Committee Action Report

**ICC A117.1 STANDARD
SECOND PUBLIC REVIEW DRAFT**

ICC A117.1 Standard – Accessible and Usable Buildings and Facilities

Committee Action Report (CAR) on Public Comments received regarding the Second Public Review Draft

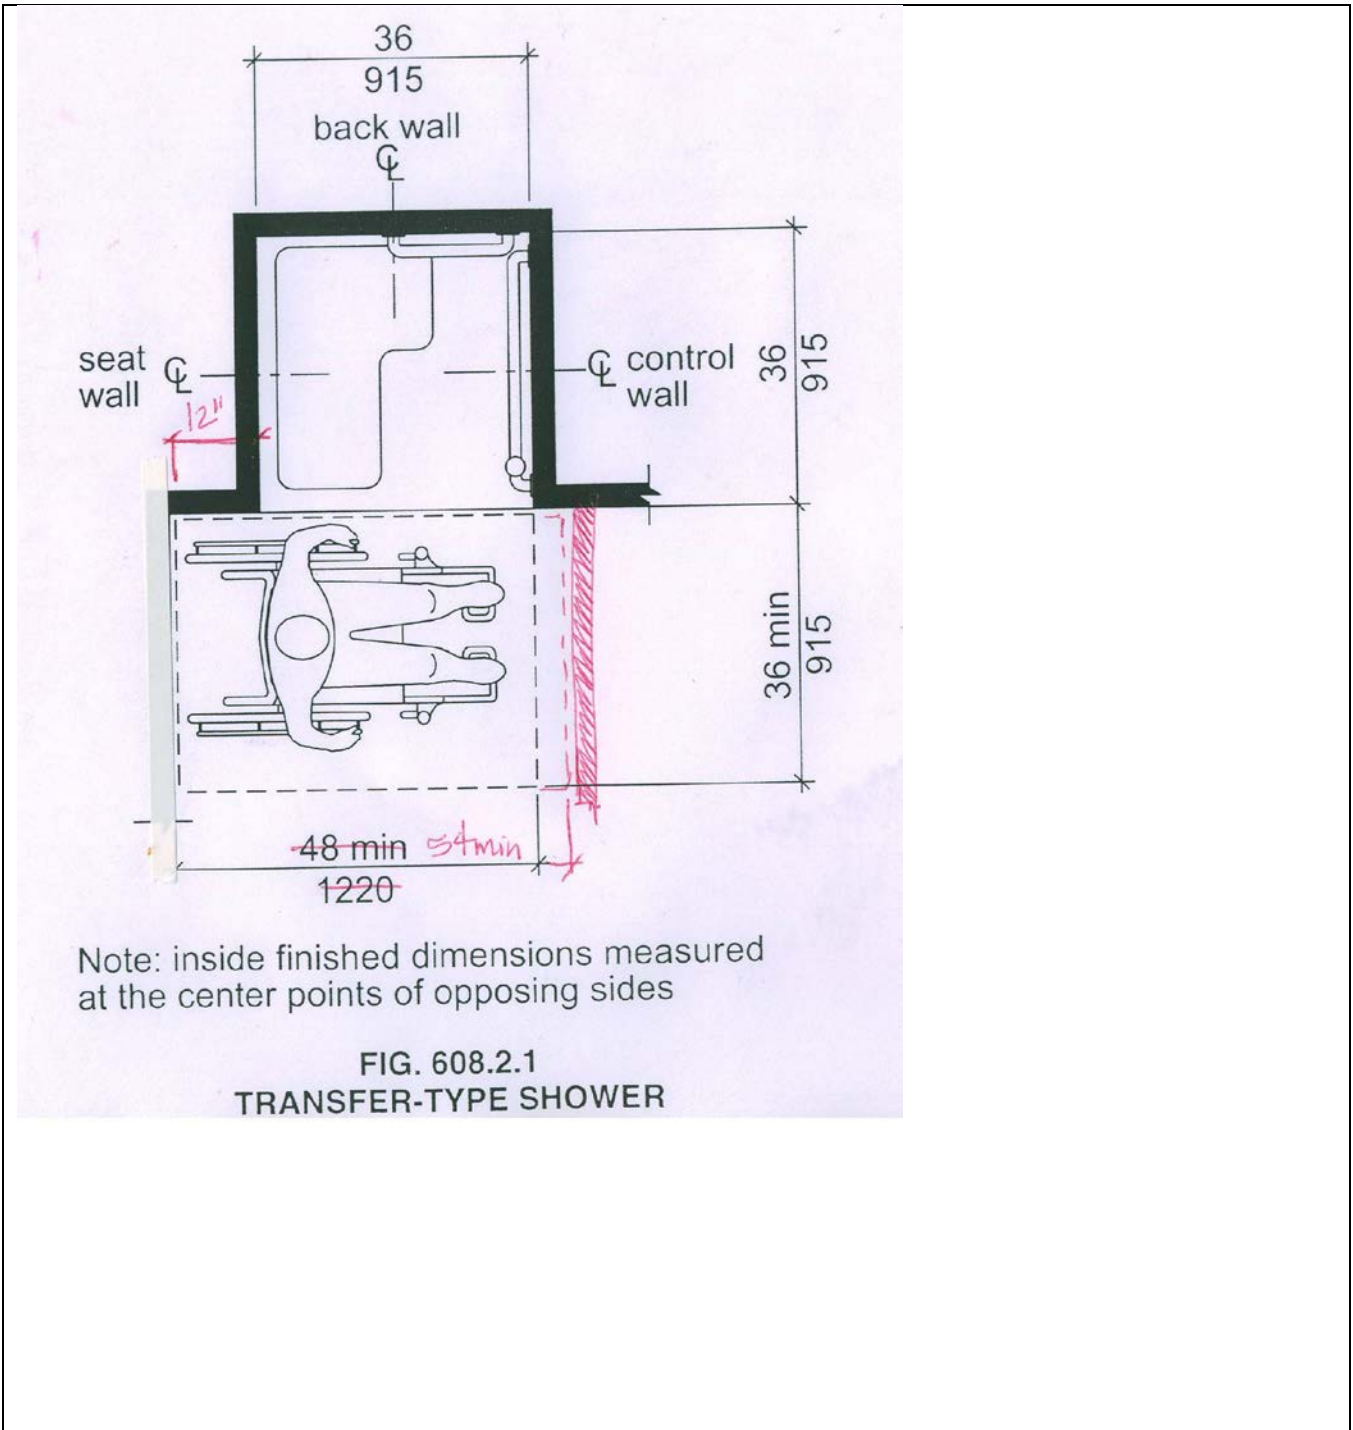
Comment No: 6-14-12 PC2.1	Submitted by: Gene Boecker – NATO
	<p>Further revise as follows:</p> <p>604.7 Dispensers. Toilet paper dispensers shall comply with Section 309.4. Dispensers shall comply with Section 609.3. Dispensers shall not be of a type that control delivery, or do not allow continuous paper flow.</p> <p>604.7.1 Location. Where the dispenser is located above the grab bar, the outlet of the dispenser shall be located within an area 24 inches (610 mm) minimum and 36 inches (915 mm) maximum from the rear wall. Where the dispenser is located below the grab bar, the outlet of the dispenser shall be located within an area 24 inches (610 mm) minimum and 42 inches (1065 mm) maximum from the rear wall. The outlet of the dispenser shall be located 18 inches (455 mm) minimum and 48 inches (1220 mm) maximum above the floor. Dispensers shall comply with Section 609.3.</p> <p>EXCEPTION: 604.7.1.1 Multiple Roll Dispensers. Where toilet paper dispensers that accommodate <u>more than a single roll</u>, a maximum of 2 toilet paper rolls of not more than 5 inch (125 mm) diameter each shall be permitted to be located 7 inches (180 mm) minimum and 9 inches (230 mm) maximum in front the of the water closet measured to the centerline of the dispenser. The outlet of the dispenser shall be 15 inches (380 mm) minimum and 48 inches (1220 mm) maximum above the floor.</p> <p>604.11.7 Dispensers. Toilet paper dispensers primarily for children’s use shall comply with Section 309.4. There shall be a clearance of 1 1/2 inches (38 mm) minimum below the grab bar. Dispensers shall not be of a type that control delivery or do not allow continuous paper flow.</p> <p>604.11.7.1 Location. The outlet of toilet paper dispensers primarily for children’s use shall be located within an area 24 inches (610 mm) minimum and 42 inches (1065 mm) maximum from the rear wall. The outlet of the dispenser shall be 14 inches (355 mm) minimum and 19 inches (485 mm) maximum above the floor.</p> <p>EXCEPTION: 604.11.7.1.1 Multiple Roll Dispensers. Where toilet paper dispensers that accommodate <u>more than a single roll</u>, a maximum of 2 toilet paper rolls of not more than 5 inch (125 mm) diameter each shall be permitted to be located 7 inches (180 mm) minimum and 9 inches (230 mm) maximum in front the of the water closet measured to the centerline of the dispenser. The outlet of the dispenser shall be 14 inches (355 mm) minimum and 19 inches (485 mm) maximum above the floor.</p>

<p>Comment Reason by Gene Boecker: The exceptions for 604.7 and 604.11.7.1 are not an exceptions as written. Exception can be used or not because they are exceptions. If the choice is made to only follow the charging section, there is no guidance on how to address the multiple roll condition. The intent is that where multiple rolls are provided, a requirement on that application must be applied. If so, then a requirement exists and a separate subsection is needed.</p>

The language in the two exceptions makes it clear that when multiple toilet paper rolls are provided, only two, of a particular dimension, are allowed. Although this requires an additional decimal indent, it addresses the concern at the proper section, in the proper manner.

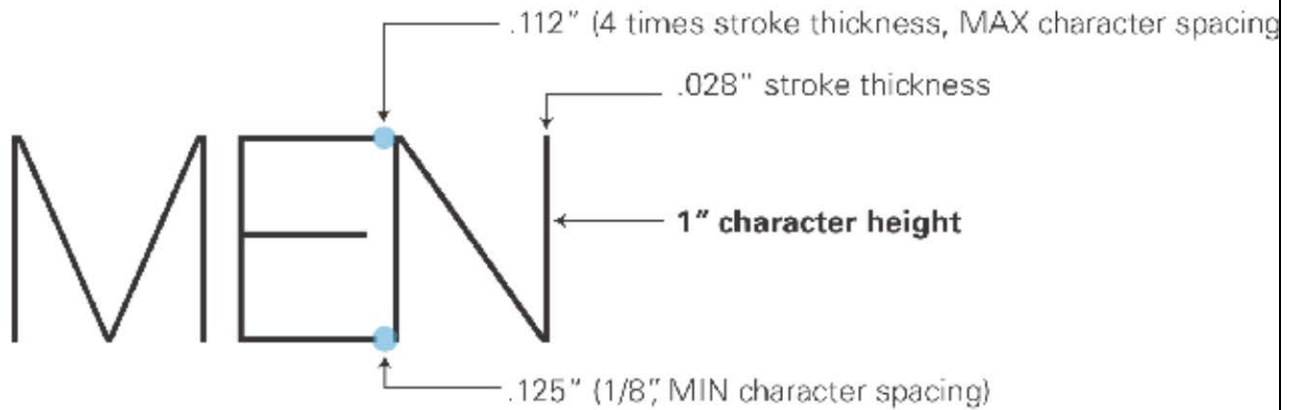
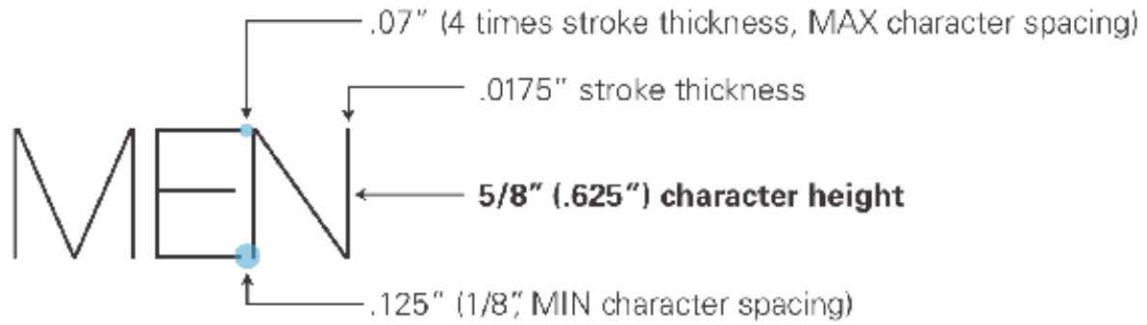
Comment No: 7-23-12 PC1.1	Submitted by: Teresa Cox – APCO Sign Systems, Inc., on behalf of ISA
	Further revise as follows: 703.3.8 Character Spacing. Character spacing shall be measured between the two closest points of adjacent raised characters within a message, excluding word spaces. Spacing between individual raised characters shall be <u>15% or 1/8 inch (3.2 mm) minimum, whichever is greater, and 35% maximum of the character height</u> measured at the top of the surface of the characters, 1/16 inch (1.6 mm) minimum measured at the base of the characters, and four times the raised character stroke width maximum. Characters shall be separated from raised borders and decorative elements 3/8 inch (9.5 mm) minimum.

Comment Reason by Teresa Cox: During our meeting in January 2014, the question was called on 7-23-12 before ISA was able to give a full explanation of the sign industry's concern. The Committee voted to reverse the action taken the previous July to address a problem with language defining maximum spacing between raised characters. The current standard reads: "Spacing between individual raised characters shall be 1/8 inch (3.2 mm) minimum ... and four times the raised character stroke width maximum." As there is no minimum stroke width for raised characters, there are instances where the 1/8 inch minimum exceeds the maximum. A PDF is attached illustrating the problem. Good design practice in signage maintains proportional spacing between characters. Spacing between characters should increase with character height. Proportional spacing enhances legibility and accessibility. Using a percentage of the character height is a logical way to define spacing between characters. The ISA did not propose to change the minimum spacing, but to allow for wider spacing than four times the stroke width.

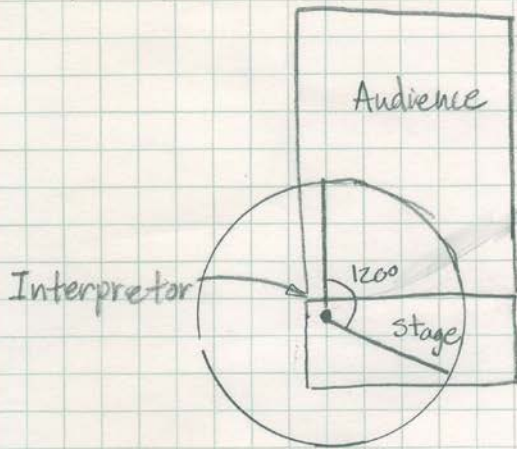
802.11.2 - The word subtend is defined in the dictionary as follows:

In geometry, an angle subtended by an arc, line, or other curve is one whose two rays pass through the endpoints of the arc. The precise meaning varies with the context. For example, one may speak of the angle subtended by an arc of a circumference when the angle's vertex is a point on the circumference. A simple theorem of plane geometry states that arcs of equal lengths subtend equal angles in such a situation.

Assuming this is the range for where the seats that have a good view of the interpreter are required, if an interpreter was standing in the middle of the stage, this might be doable. However, the most common place for an interpreter is at the side of the stage. This literally would require the viewing area to be behind them. See Figures. The maximum” could be read to indicate that the angle could be anything up to that range in width – including 0 degrees – which I don't think was the intent. ‘Unobstructed’ to 65 feet could be interpreted to not allow any columns in the room in that area. Thus the room we have our A117.1 meetings in would be in violation. Since an interpreter could be of any height, using the size of the interpreter for the viewing range is not consistent.

Interpreter at center of stage

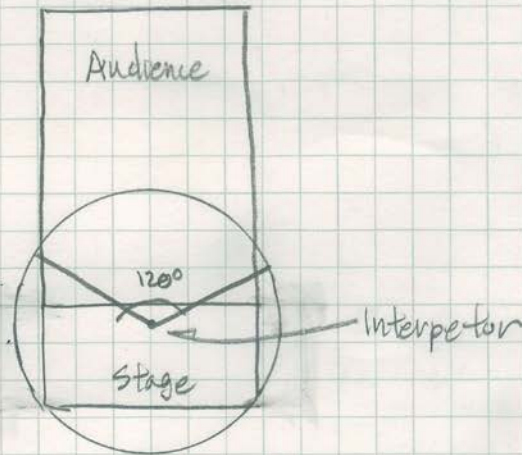
The intent of the revisions to the last sentence is intended to provide more precise information of measurement. However, this requirement should probably be deleted because it could prohibit seating immediately in front of the interpreter when the interpreter is on any type of raised platform or stage.
